RESPONSE TO HCGS SER OPEN ITEM 3  
HOPE CREEK GENERATING STATION  
DOCKET NO. 50-354

PSE&G RESPONSES TO NRC REQUEST FOR  
ADDITIONAL INFORMATION NUMBER 1 (RAI-1)  
REGARDING THE HOPE CREEK GENERATING STATION  
PRE-SERVICE INSPECTION PROGRAM

# CRC WELD

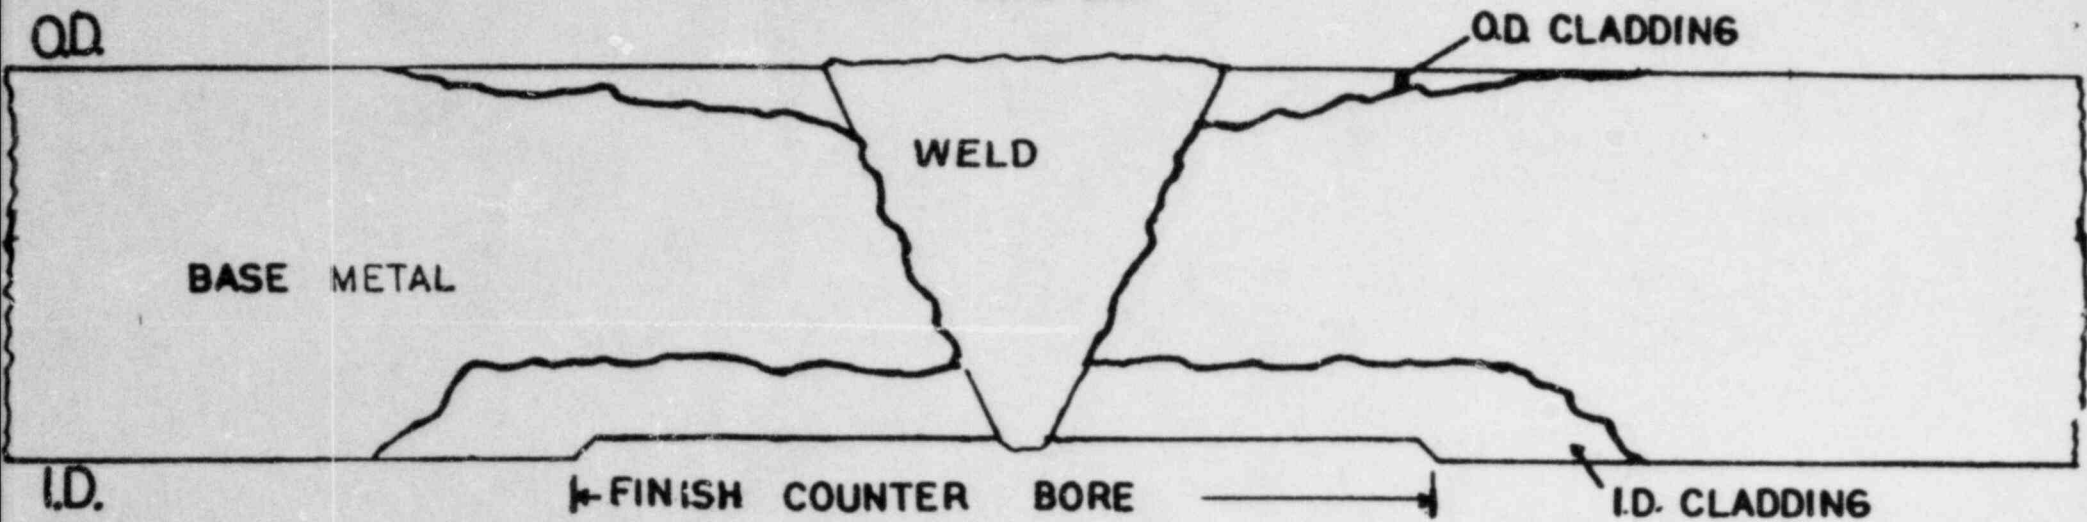
The staff review of the PSI plan indicates that the use of cladding on piping welds may interfere with effective ultrasonic examination. Plans for qualification of the volumetric examination procedure to be used on the subject welds should be discussed. Standard, minimum code radiography may not be capable of detecting service-induced degradation because the detection of cracks is strongly dependent on the angle of the central axis of the radiation beam with respect to the predominant crack plane. If radiography is planned, provide the technical justification, including qualifications and procedure requirements to demonstrate that the radiography procedure is effective for volumetric examinations.

The Applicant should also provide detailed information describing the specific welds with corrosion resistant cladding and typical dimensions of the cladding.

In addition to the information presented by PSE&G on November 26, 1984 (see NRC meeting summary dated December 18, 1984, for details), the NRC requested more detailed information on typical cladding dimensions of CRC weld joints. Attachment 2 shows sketches of the Reactor Recirculation Loop piping Loop A and B and cladding dimensions for various nominal pipe sizes.
